UNITED STATES PATENT AND TRADEMARK OFFICE

10/803,189

Office Action Summary

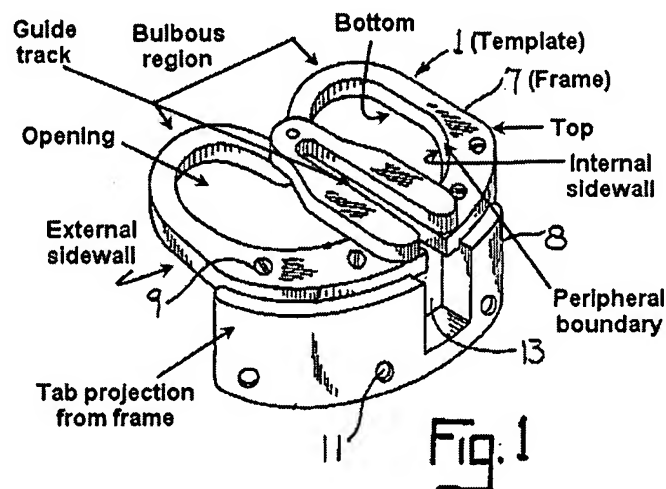
Dietz et al. (herein Dietz) discloses a template (1) comprising: a frame (7) having a top, a bottom, one or more external sidewalls, and one or more internal sidewalls (see Figure 1 below), said frame (7) having one or more openings extending there through from said top to said bottom wherein at least one of said one or more internal side walls defines a peripheral boundary of each of said one or more openings (see Figure 1 below; col. 2, lines 38-39); a guide track (15,18; see Figure 1 and 6 below) formed in said one or more internal sidewalls, said guide track (15,18) receiving a guide of a bone milling device (col. 2, lines 16-21) whereby said bone milling device may be moved about said peripheral boundary using said guide track (15,18; col. 2, lines 16-12 and 58-67; col. 3, lines 1-19). It is noted that Dietz explicitly discloses another embodiment where the template contains a track for guiding the bone milling device (see Figure 6

The means for removably securing includes one or more tabs (pre-bent) projecting from said frame (7) which have one or more securing points which may be secured to a bone (col. 2, lines 28-36). One or more tabs project from said one or more external side walls (see Figure 1 below).

is capable of being used as claimed if one so desires to do so. The peripheral boundary has one or more bulbous regions (see Figure 1 below).

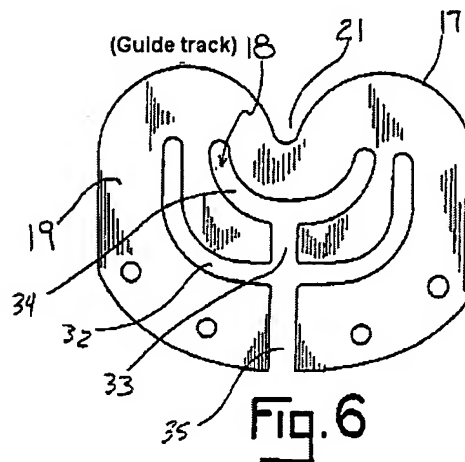
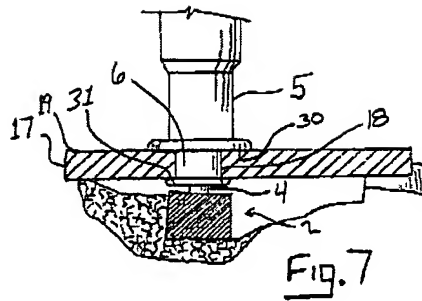
The guide track (15,18; see Figure 1 and 6 below) is positioned approximately midway between said top and said bottom of said frame (7). The guide track (15,18) has a flat lower surface, which is approximately parallel to said top and said bottom of said frame (col. 2, lines 39-61). The guide track (15,18) has an angled upper surface which projects at an angle from said lower surface to a point relatively closer to said top of said frame than said bottom of said frame (col. 2, lines 39-67 and col. 3, lines 1-19). The guide track (15,18) has an arcuate upper surface, which extends from said lower surface to a point relatively closer to said top of said frame than said bottom of said frame (col. 2, lines 65-67 and col. 3, lines 1-19). The guide track (15,18) has an arcuate lower surface and an angled upper surface which projects at an angle from said lower surface to a point relatively closer to said top of said frame than said bottom of said frame (col. 2, lines 65-67 and col. 3, lines 1-19).
